Project	IEEE 802.16 Broadband Wireless Access Working Group < http://ieee802.org/16 >	
Title	802.16g Figure 1 issues	
Date Submitted	2005-03-16	
Source(s)	David Johnston Intel Corporation	Voice: (503) 264 3855 Email: dj.johnston@intel.com
Re:	Call for comments	
Abstract		
Purpose	This document attempts to clarify what delta changes 802.16g should make to 802.16-2004 (as amended by succeeding amendments)	
Notice	This document has been prepared to assist IEEE 802.16. It is offered as a basis for discussion and is not binding on the contributing individual(s) or organization(s). The material in this document is subject to change in form and content after further study. The contributor(s) reserve(s) the right to add, amend or withdraw material contained herein.	
Release	The contributor grants a free, irrevocable license to the IEEE to incorporate material contained in this contribution, and any modifications thereof, in the creation of an IEEE Standards publication; to copyright in the IEEE's name any IEEE Standards publication even though it may include portions of this contribution; and at the IEEE's sole discretion to permit others to reproduce in whole or in part the resulting IEEE

2 Proposed Stack Layering in DOC 010

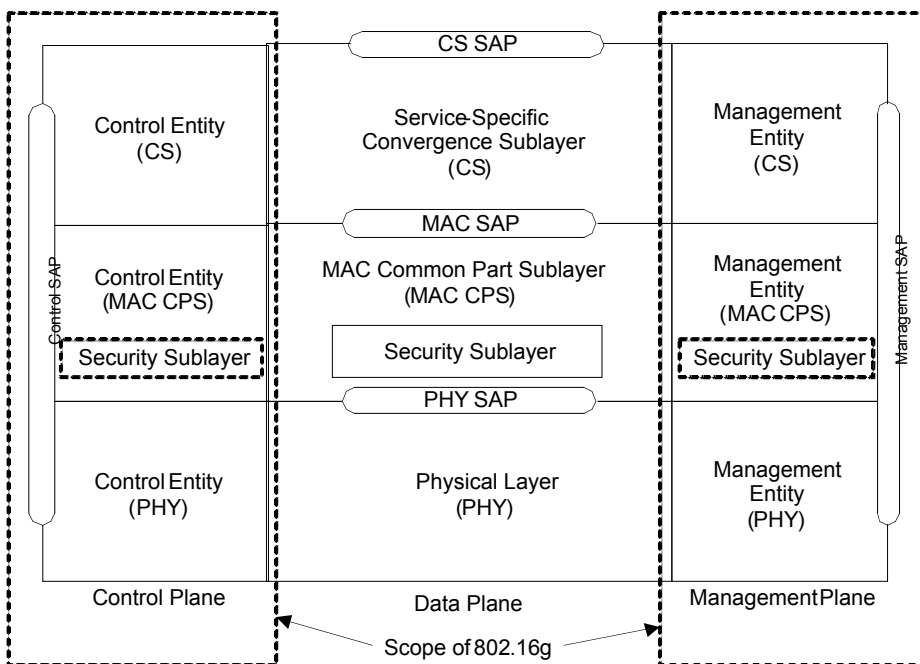
Some observations:

This diagram does not describe the diagram that 802.16g would insert into 802.16-200x. Taking 802.16-2004 as an example, the diagram describes data and management planes, data plane interfaces and outlines the scope of 802.16-2004 as being limited to the data plane.

The diagram above separates out control and management planes. This may be an appropriate separation of function in 802.16g, however this separation of function is not expressed in the base document. As such, the control/management split may be considered a hierarchical split underneath the management plane as expressed in the base document.

The scope of 802.16g in the above diagram is limited by the PAR to management procedures and logically this would correspond to the dotted rectangle on the right hand side of the above diagram.

Replace figure 1 with:

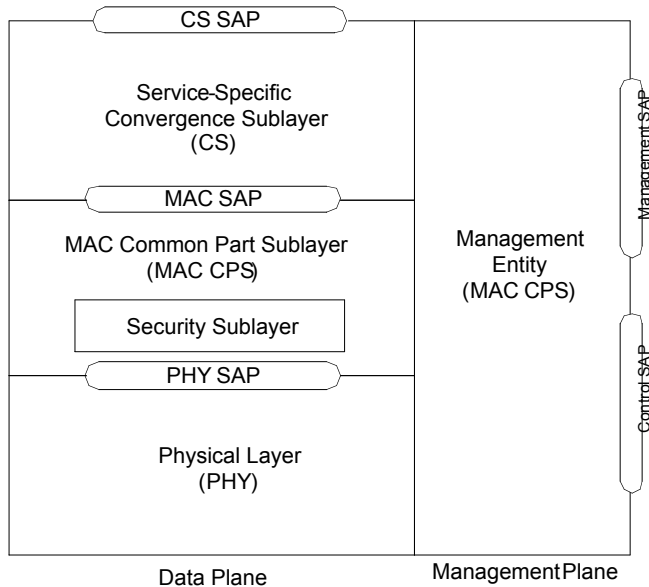
802.16g will create an amendment that leads to a specification with a scope encapsulating both data and management planes.

The internal separation of MAC, PHY and CS does not map to the data plane separation and implies that separate control and management SAPs for each layer are required.

Accordingly, the stack diagram in Doc 05-010r1 is appropriate for either informative material describing the scope and internal structuring of 802.16g, however the actual diagram in 802.16 that is proposed as a replacement for figure 1 in the base 802.16 would map this structure into the base document’s diagram.

Accordingly we might expect something along the lines of..

Explanation:

This diagram maps both interfaces into the management plane in the base standard, while they may still hook into the separate control and management entities expressed in 802.16g.

The dotted line scope delimiter is removed, since the scope of the amended specification will encapsulate the whole of the stack, even though the scope of 802.16g is limited to the management side.

The dotted line separation of security management appears superfluous, given that the security management protocols obviously appear in the management plane along with all the other management protocols. With the network model and SAPs proposed, we might expect primitives related to security to appear on one of the management SAPs and map to the interface to the ASA in the proposed network model. Accordingly in the proposed diagram there is no separation of the security management entity.

[Replace figure 1 with the following diagram]

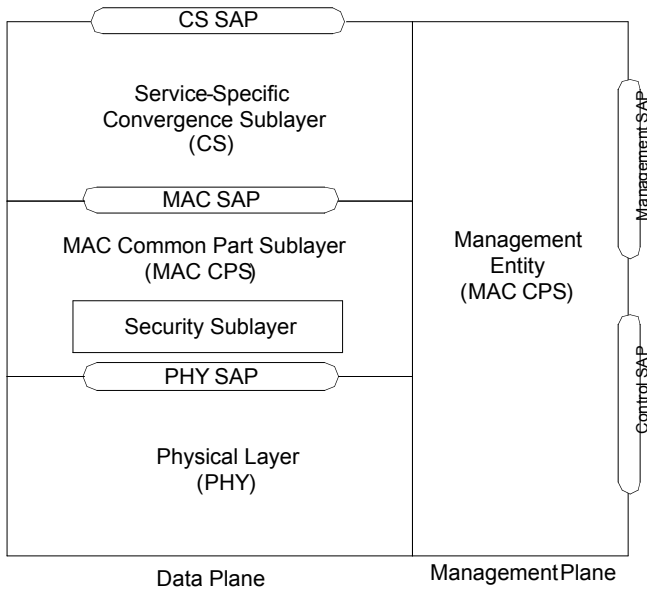
Option 1

14.4.1.1.2.1 Control SAP

[Add a bullet item]

- AAA server signaling (E.G. EAP payloads)

[Replace figure 1 with the following diagram]

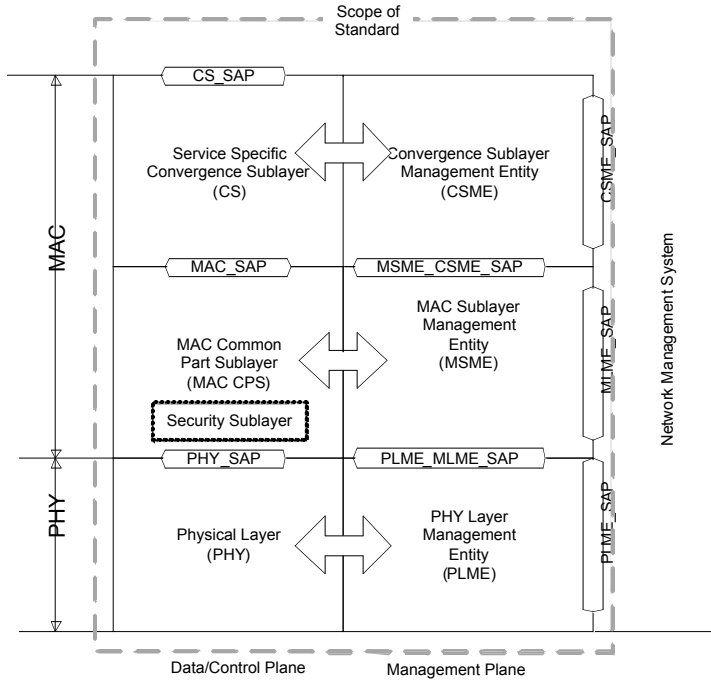
Option 2

14.4.1.1.2.1 Control SAP

[Add a bullet item]

- AAA server signaling (E.G. EAP payloads)

[Replace figure 1 with the following diagram]

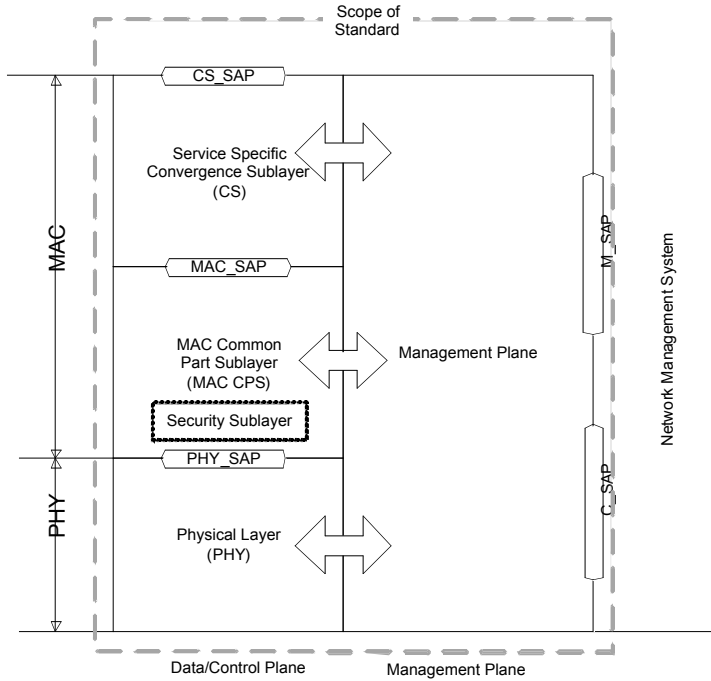
Option 3

14.4.1.1.2.1 Control SAP

[Add a bullet item]

- AAA server signaling (E.G. EAP payloads)
